Fall Mountain Farm

Site Plan 2026
New Parking with Current Parking

PCD File No. AL2611

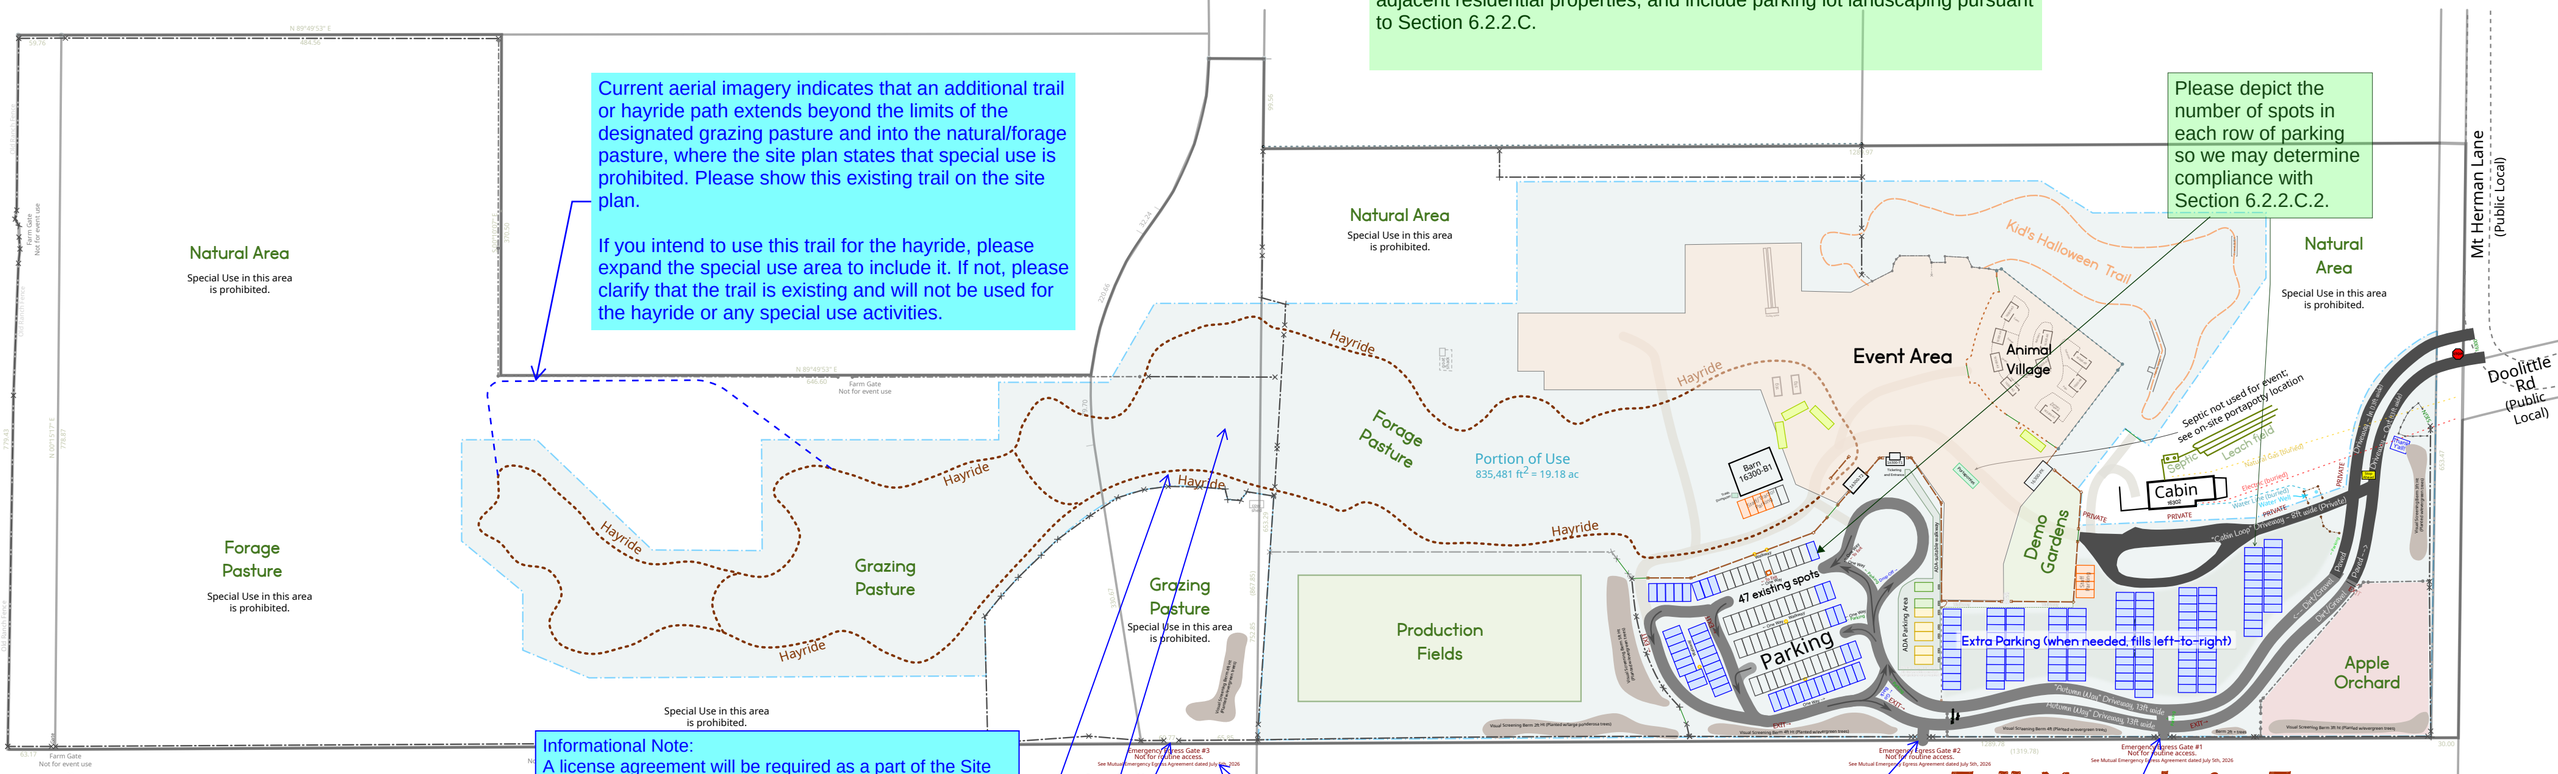
Please depict how the parking lot will be screened from roadways and adjacent residential properties, and include parking lot landscaping pursuant to Section 6.2.2.C.

Please depict the number of spots in each row of parking so we may determine compliance with Section 6.2.2.C.2.

Current aerial imagery indicates that an additional trail or hayride path extends beyond the limits of the designated grazing pasture and into the natural/forage pasture, where the site plan states that special use is prohibited. Please show this existing trail on the site plan.

If you intend to use this trail for the hayride, please expand the special use area to include it. If not, please clarify that the trail is existing and will not be used for the hayride or any special use activities.

These emergency accesses can only be approved by the County if there is a legal recorded joint access and maintenance agreement recorded on file with the EPC Clerk and Recorder's Office. Per the updated LOI, if a recorded agreement will not be obtained, please remove the emergency access from the site map and references to the emergency accesses from the LOI/Applicant Response.

Please note that the emergency access is not required to fulfill the criteria of approval for legal and physical access.

If you wish to retain the emergency access on the site plan, please include a note in the LOI that a joint access easement and maintenance agreement will be recorded at the site development plan phase.
